JACKET NUMBER PR-60 (7)
PROPOSED (52 FR 5992)

Re: Comment on ANPR - Definition of "High-Level Radioactive Waste"
Fed. Reg. Vol. 52, No. 39, p. 5992, February 27, 1987

**AN APPROACH TO DEFINING DE MINIMIS,
INTERMEDIATE AND OTHER CLASSES
OF RADIOACTIVE WASTE**

**COMMENTS ON
THE NUCLEAR REGULATORY COMMISSION'S
ADVANCED NOTICE OF PROPOSED RULEMAKING**

Fig. 1. Waste classification format. (Paper 7)

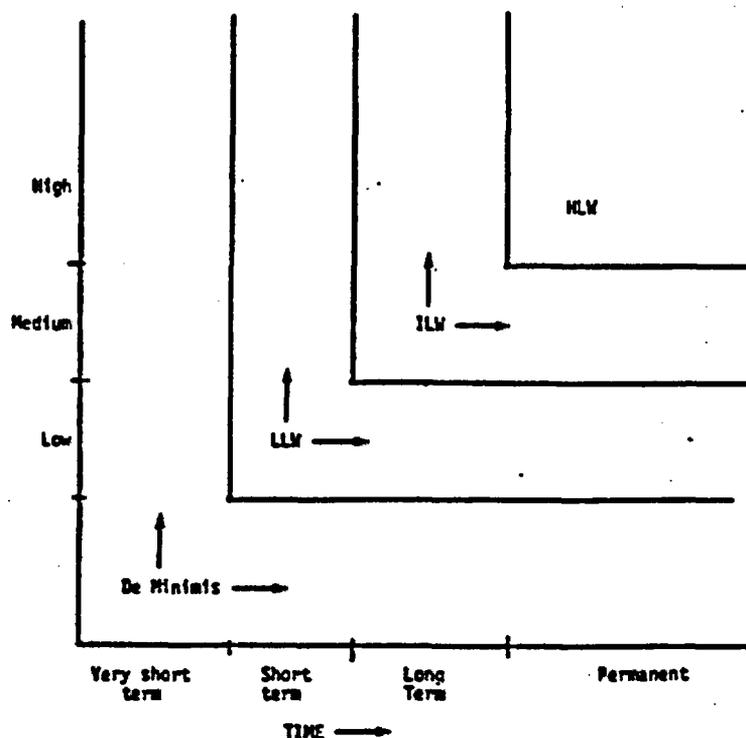
An approach has been developed that reflects both concerns in the framework of a radioactive waste classification system. This approach is depicted in Fig. 1. In this approach, the class of any radioactive waste stream is dependent on its degree of radioactivity and its persistence. To be consistent with conventional systems, four waste classes are defined. In increasing order of concern due to radioactivity and/or duration, these are
